ADDENDUM NO. 3:

Date: February 10, 2026
 Project: Verbena HS Gym
 DCM# 2025629
 WSM# 25-032

Owner: Chilton County Board of Education
 Architect: Ward Scott Morris Architecture, Inc.

FLOOR PLAN -
GYMNASIUM**A101****1 FLOOR PLAN - GYMNASIUM**
1/8" = 1'-0"

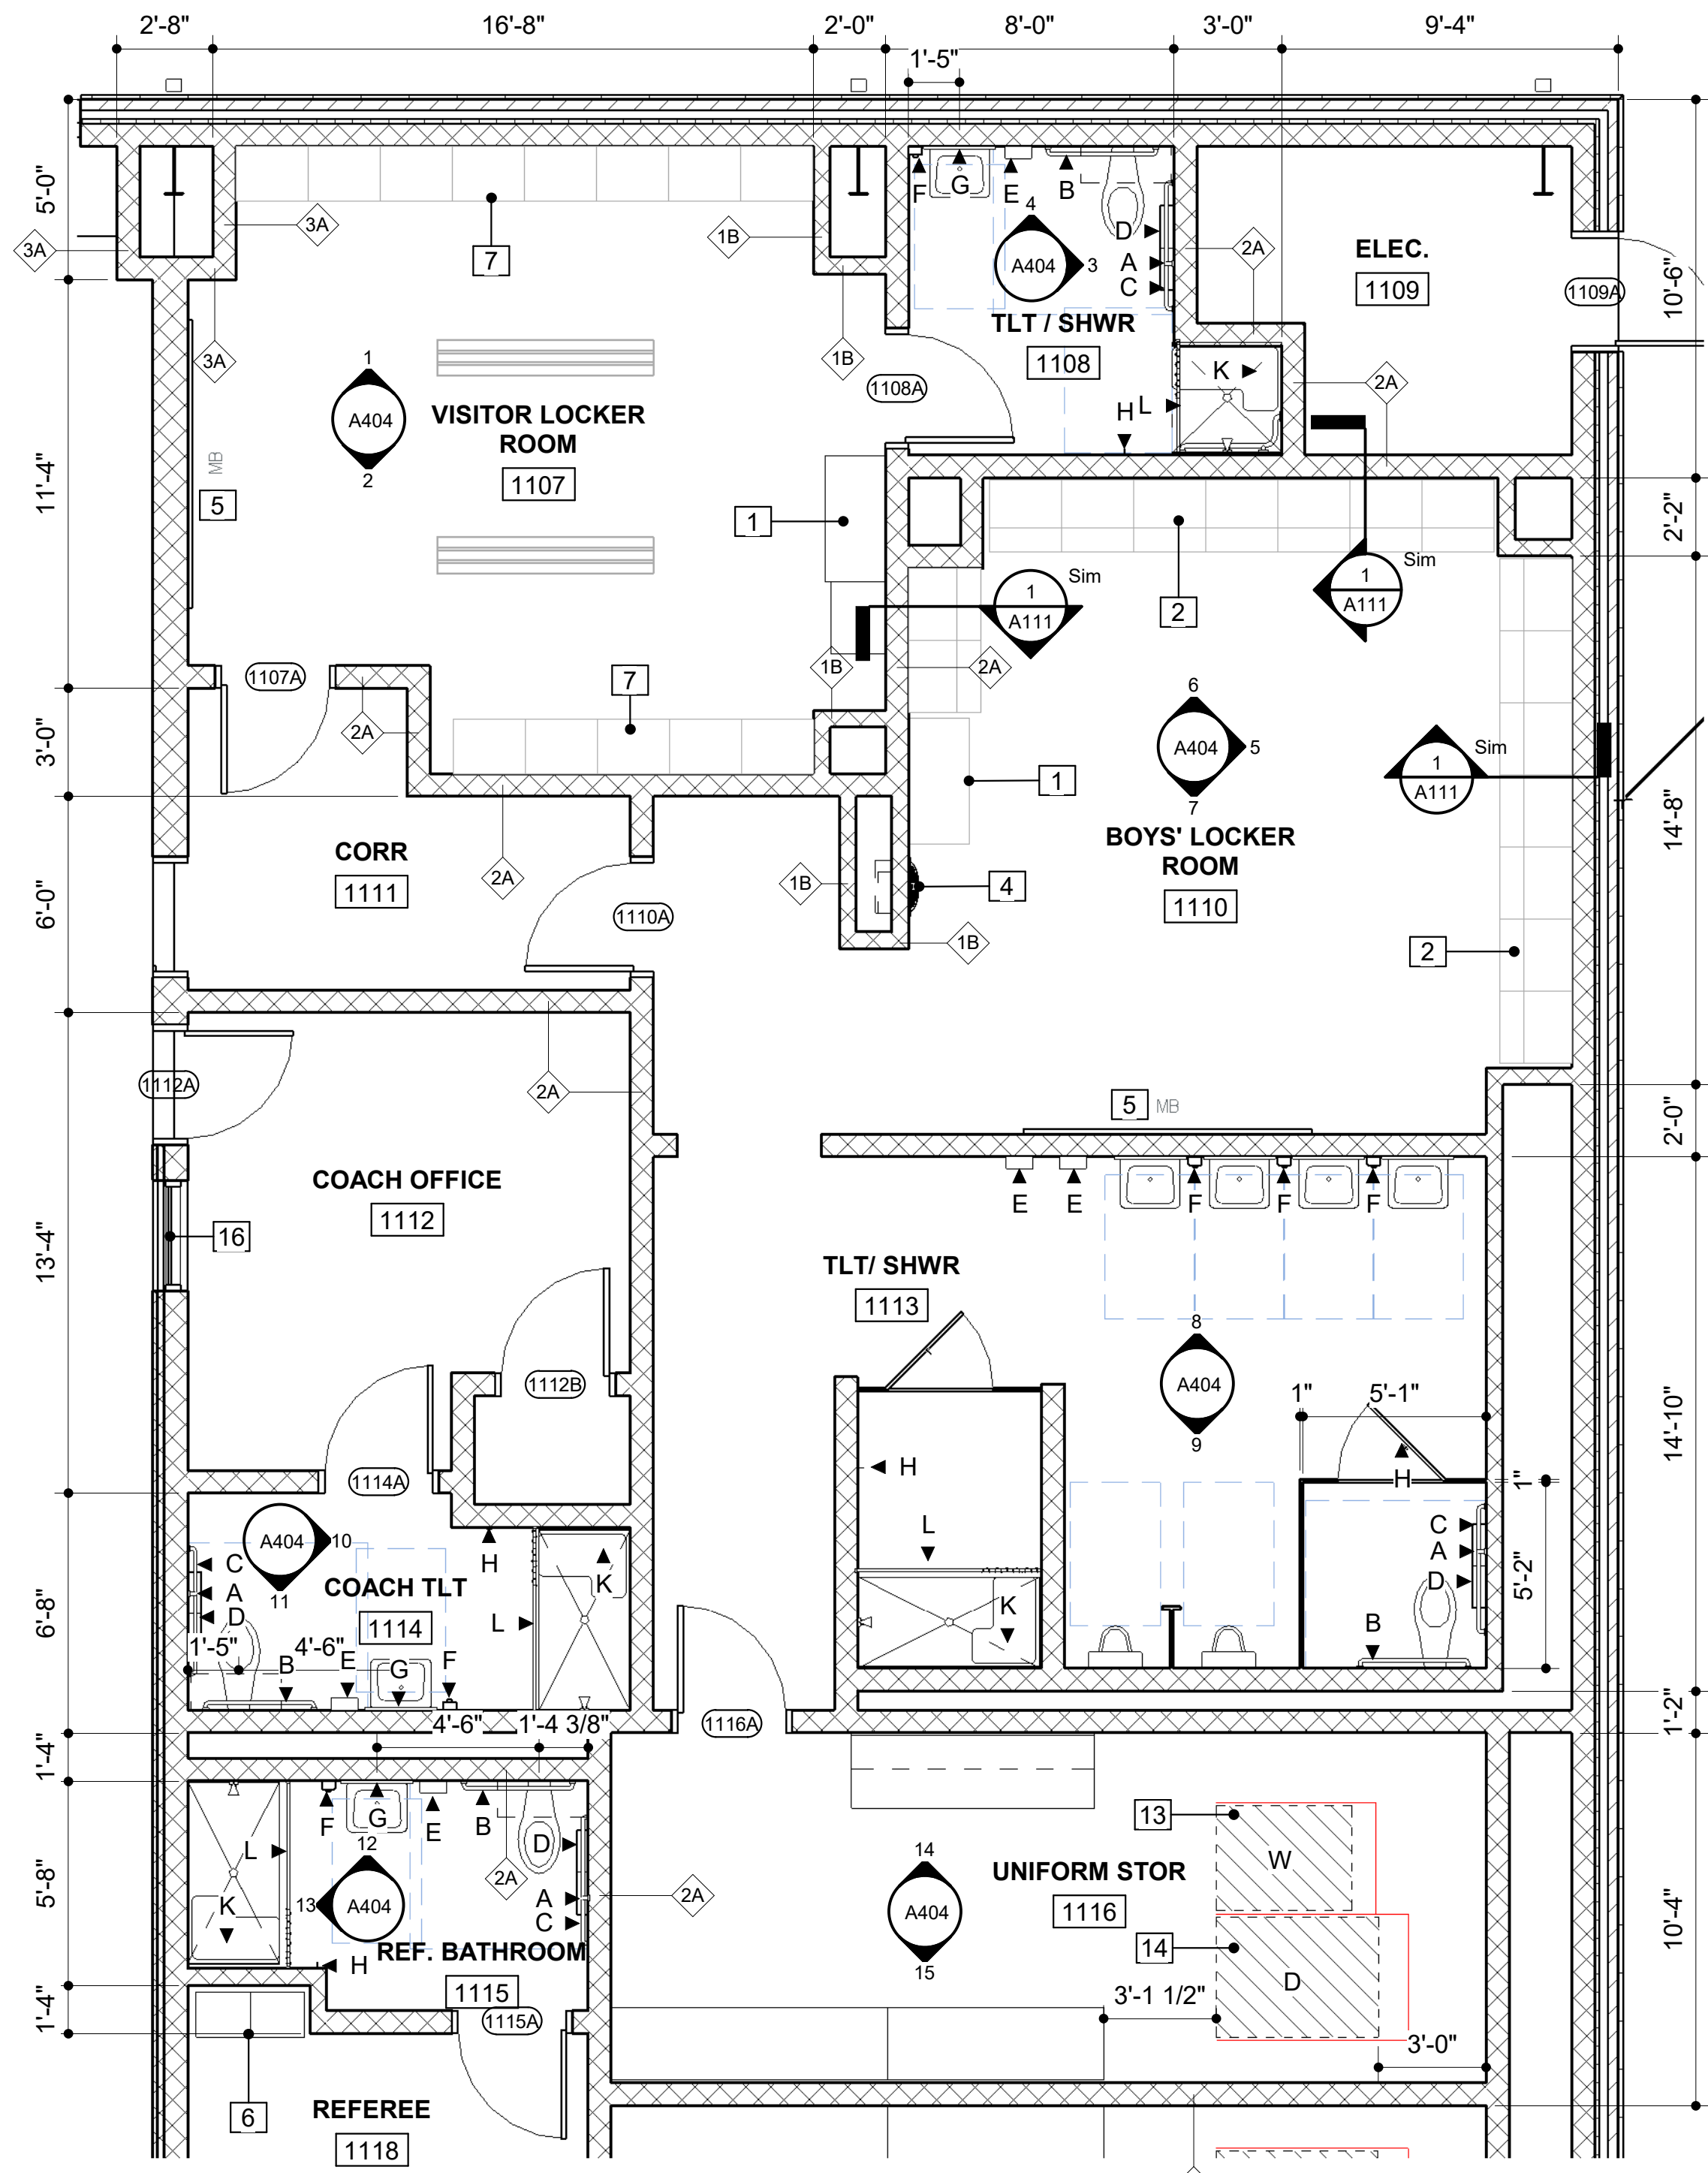
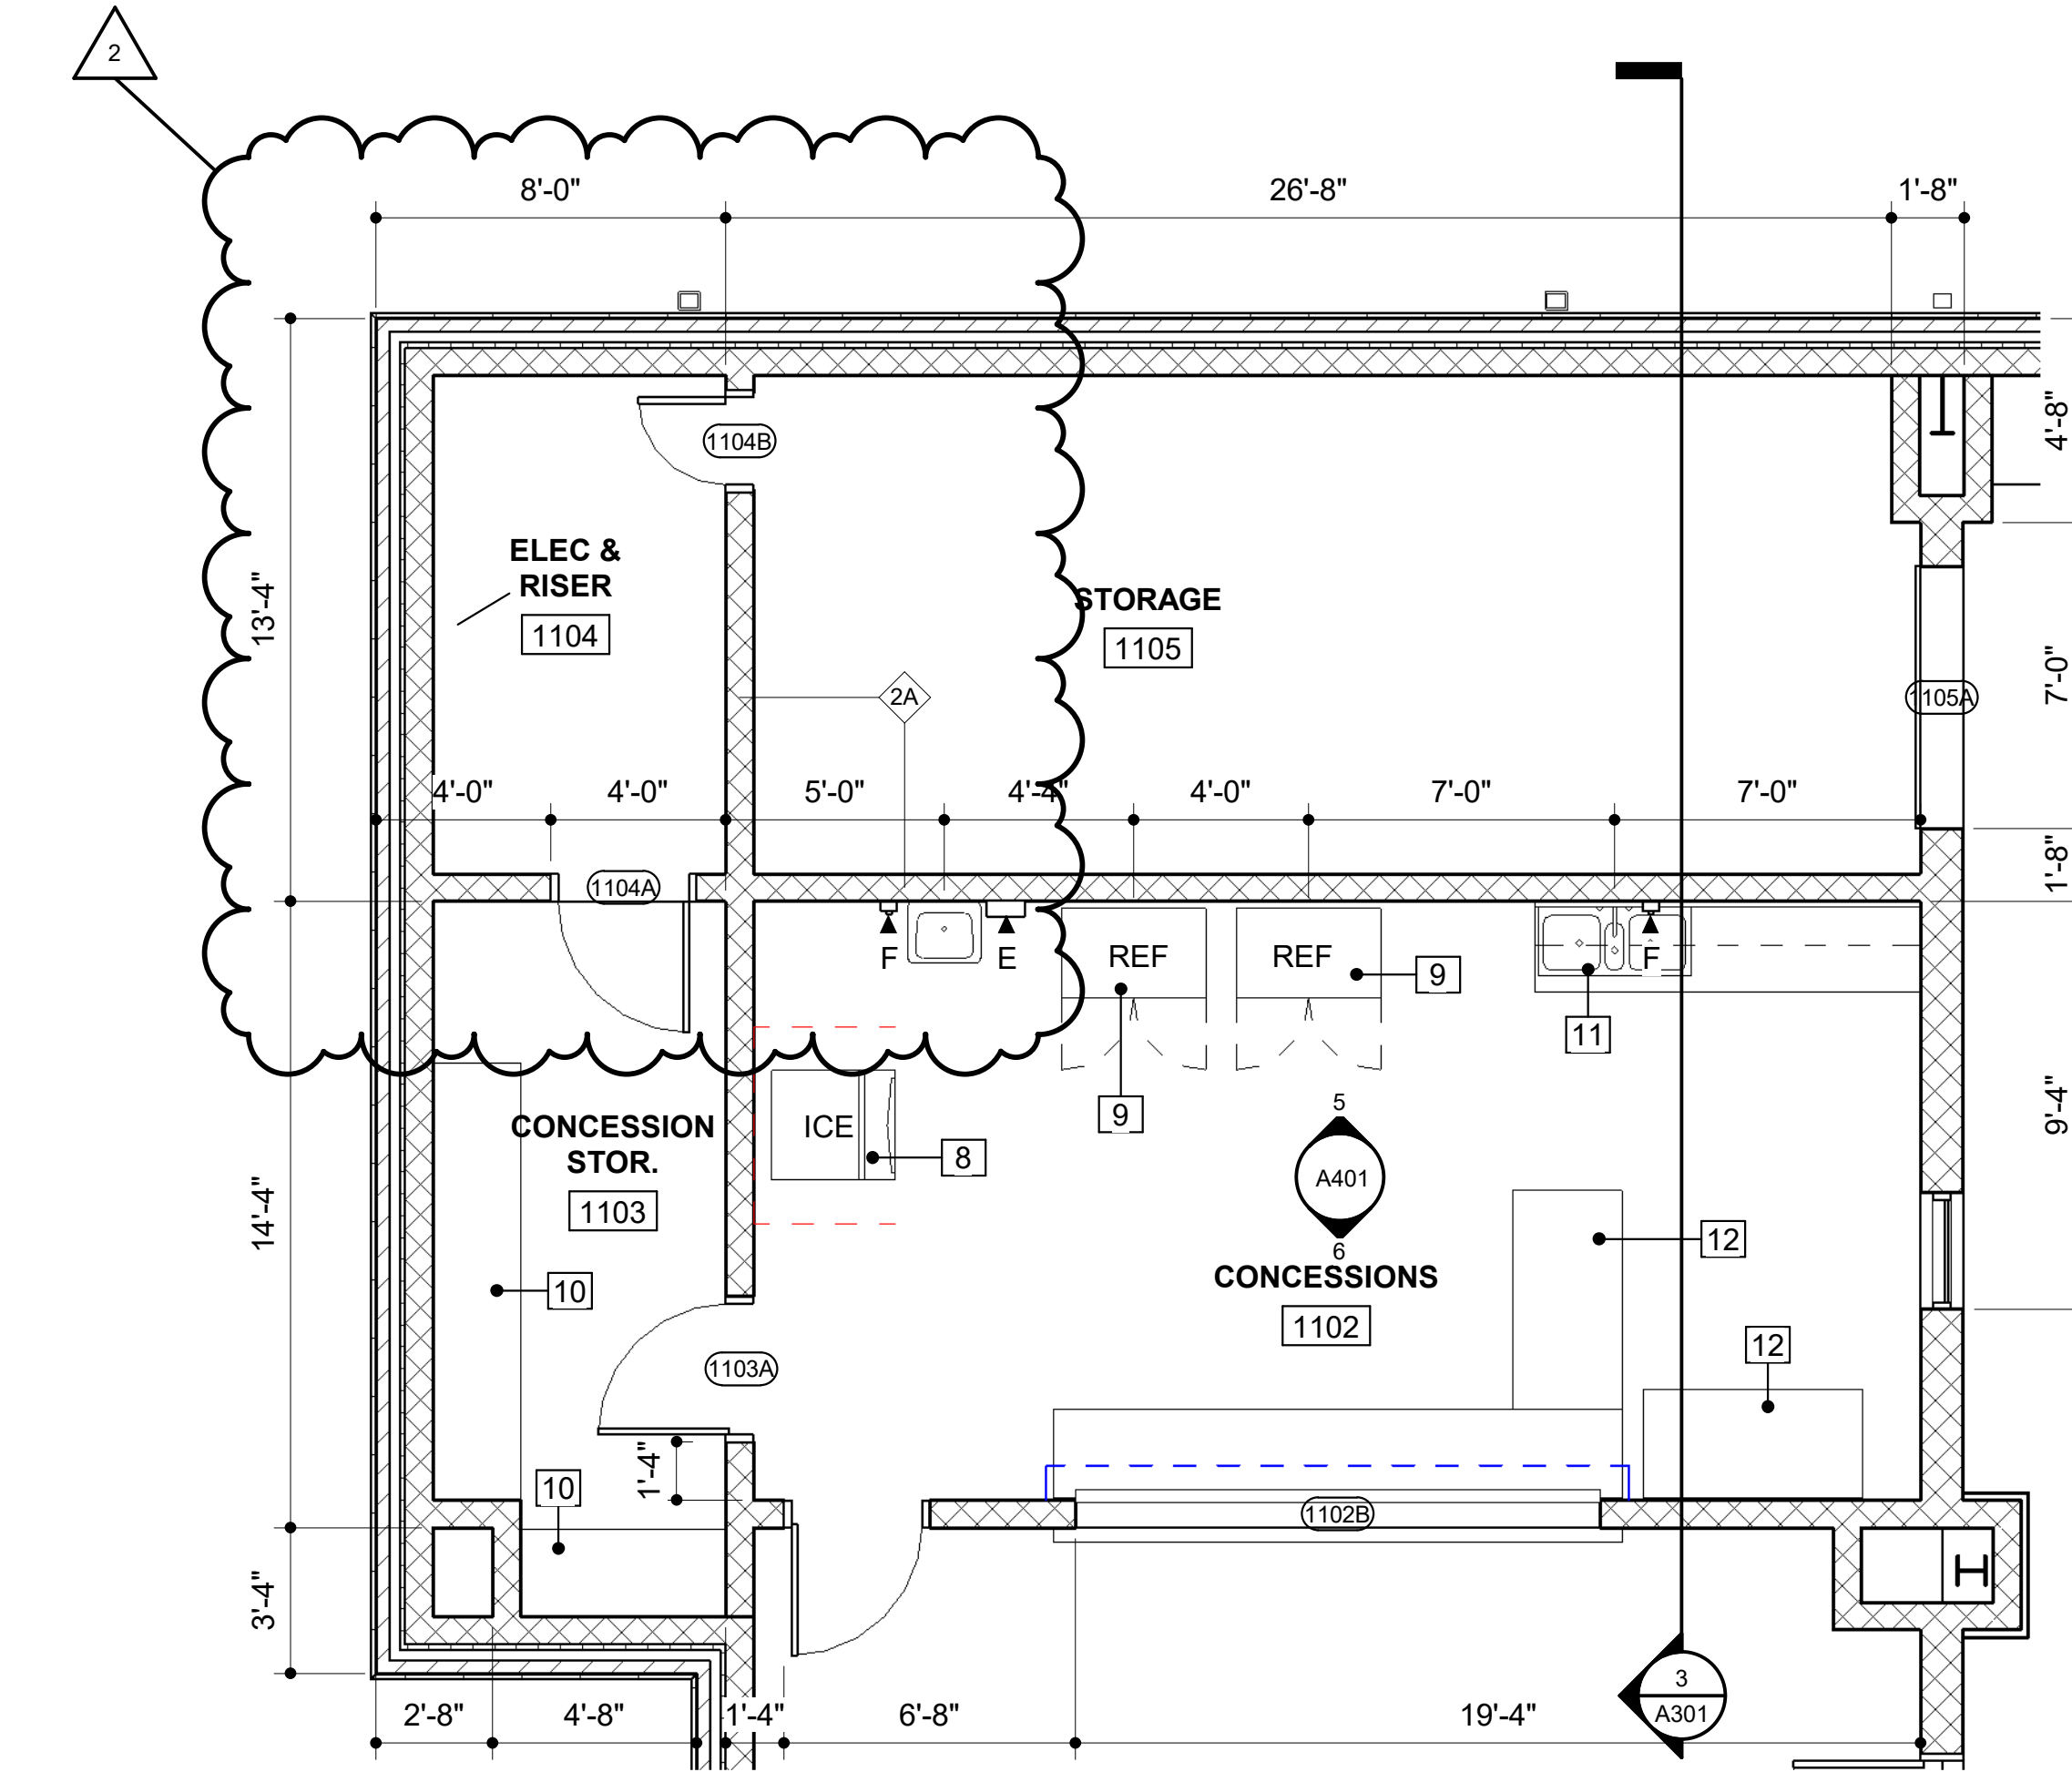
- A. Structural Sheets S000, S100, S500; Refer to attached revised drawings for wall relocation between Rooms #1104 and #1105.
- B. Sheets A002; Refer to attached revised drawing for door and glazing changes.
- C. Sheets A101, A111 and A301; Refer to attached revised drawings for wall relocation and door added between Rooms #1104 and #1105.
- D. Sheet A103; Kitchen Equipment Schedule; change R/F model numbers to TS-24F-FLX-HC, TS-23F-FLX-HC, all stainless-steel exterior.
- E. Sheet A103 and A111; Addendum No. 1 item 1.3.H; R/F-2; change this model number to TS-49FG-FLX-HC-FGD01, all stainless-steel exterior.
